Work Order ID 87561

Item Name: Crosstube Turning Detail

DART AEROSPACE LTD		Work Order: 87561
Description: Crosstube Assembly (205/212/412 High Fwd)		Part Number: D212-664-141
Inspection Dwg: D212-664-141 Rev: D		Page 1 of 2

DRAWING NO. D212-664-141	TITLE XTUBE ASSY (205/212/412 HI FWD)	REV. D	DART AEROSPACE LTD ENGINEERING ORDER		D.E.O. NO. D212-664-141-D-1	SHEET NO. SHEET 1 OF 2	SCALE NTS
DRAWN	CHECKED <i>OP</i>	MFG. APPR. <i>ER</i>	APPROVED <i>MP</i>	DE APPR. <i>MP</i>			
DATE 11.04.07	DATE 11.07.11	DATE 11.04.12	DATE 11/04/12	DATE 11.04.12

**D212-664-141/-141B
ASSEMBLY DETAIL**

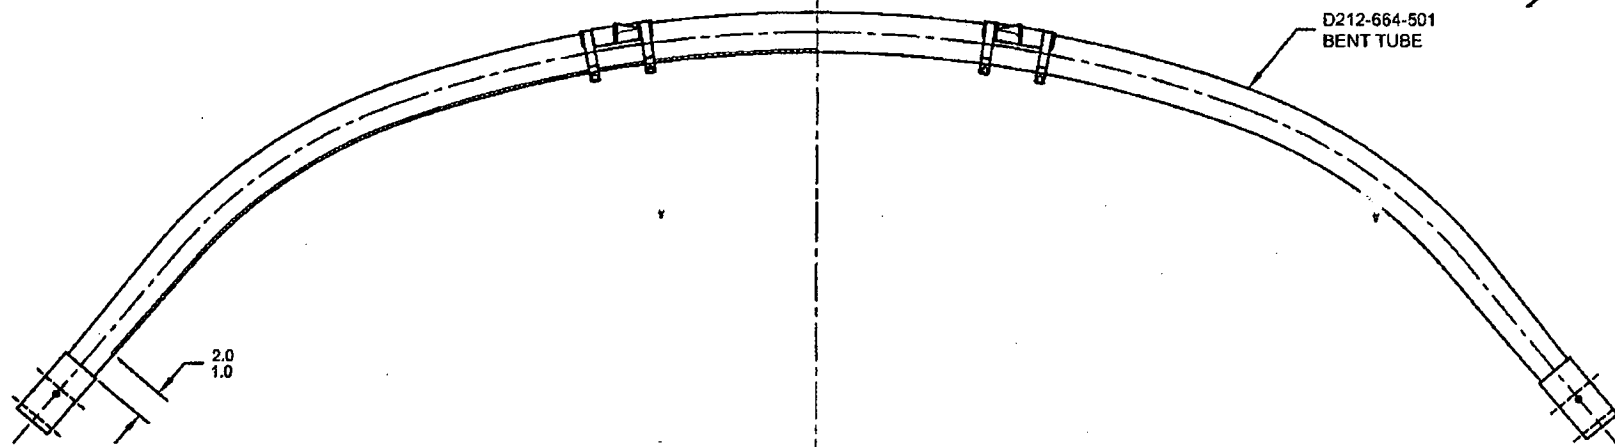
PURPOSE:

ADD AN INSPECTION WINDOW TO UNDERSIDE OF CROSSTUBE.

MASK AREA PRIOR TO PAINTING,
REMOVE MASKING AFTER PAINT
AND APPLY CLEAR COAT
